Subject: FW: TSC Comments Kings Forest Project Application Mod 3 Service Station DA11/0565.04 (MP08/0194)

Subject: TSC Comments Kings Forest Project Application Mod 3 Service Station DA11/0565.04 (MP08/0194)

MAP 2

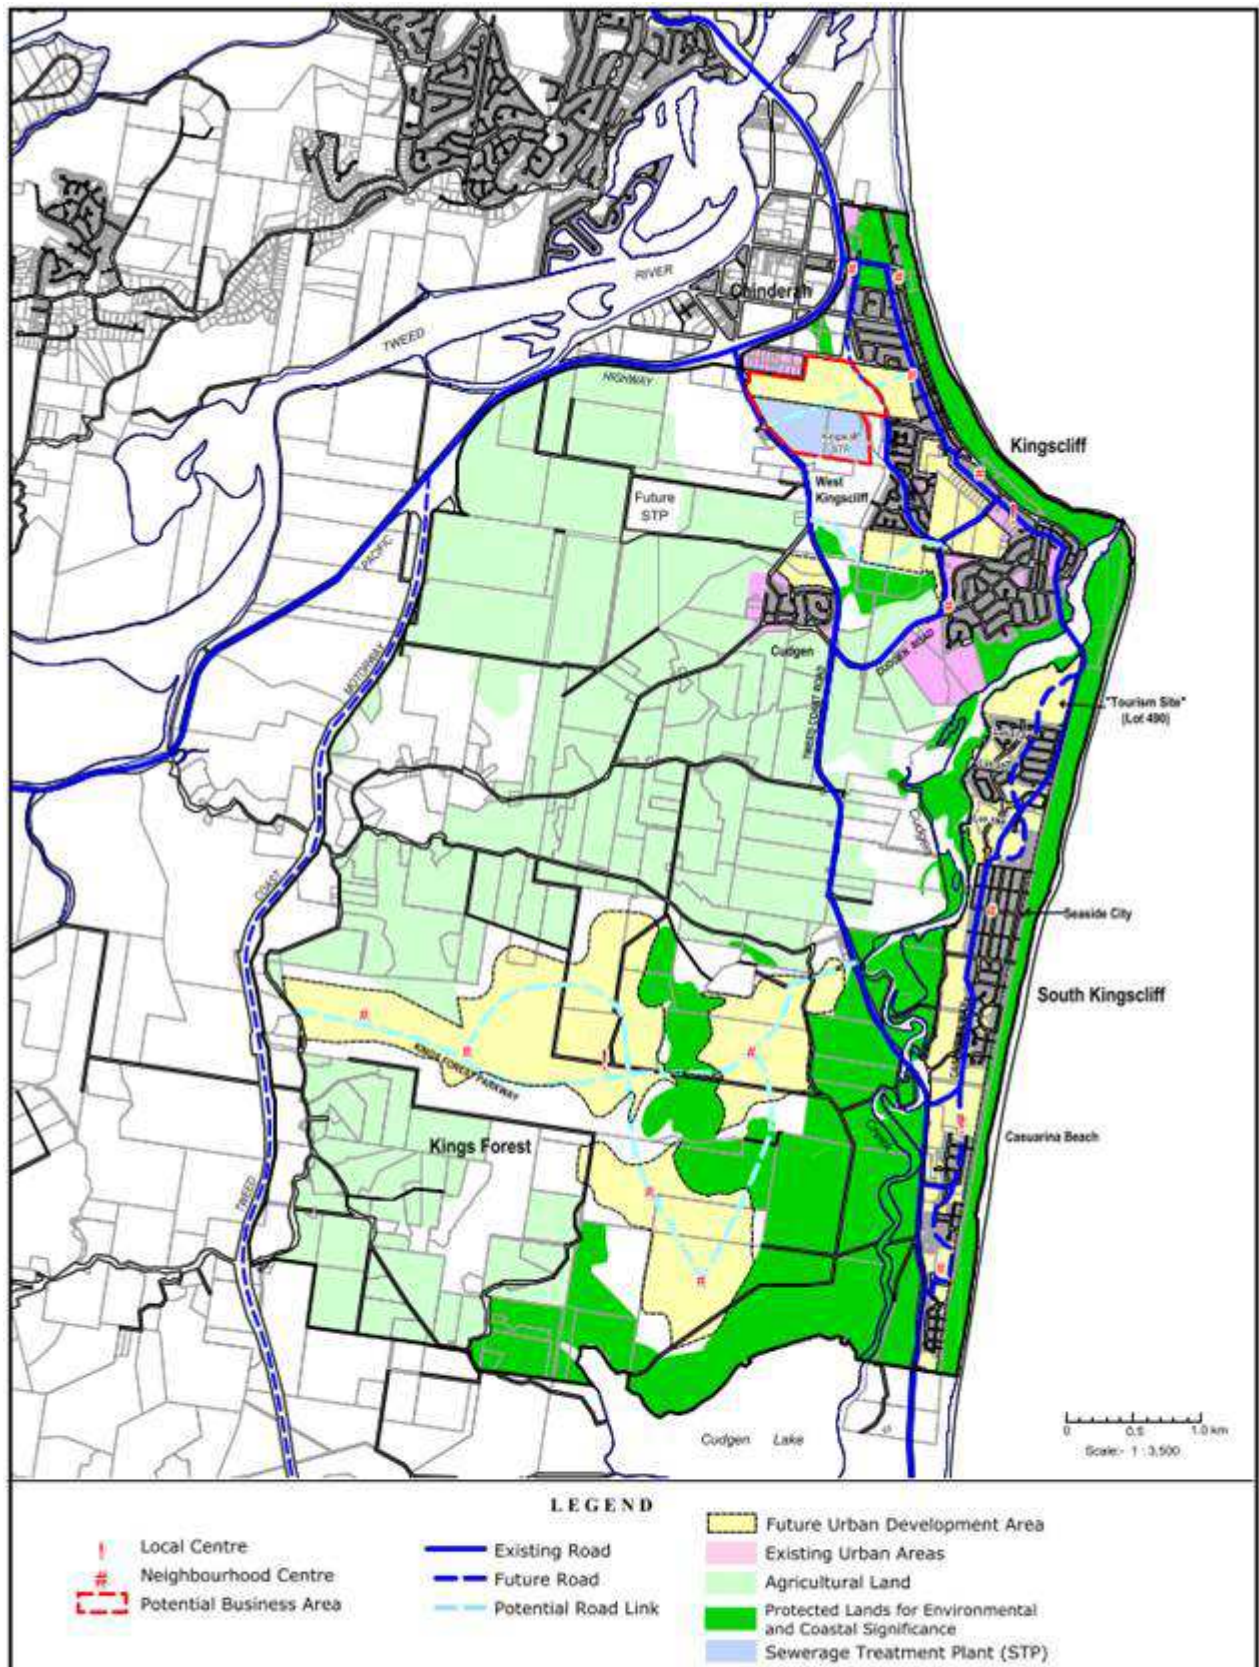
It is recommended that these elements of Section B9 be addressed in more detail in the assessment of the current application.

An extract from Map 2 is as follows which shows the intended green belt along Tweed Coast Road:
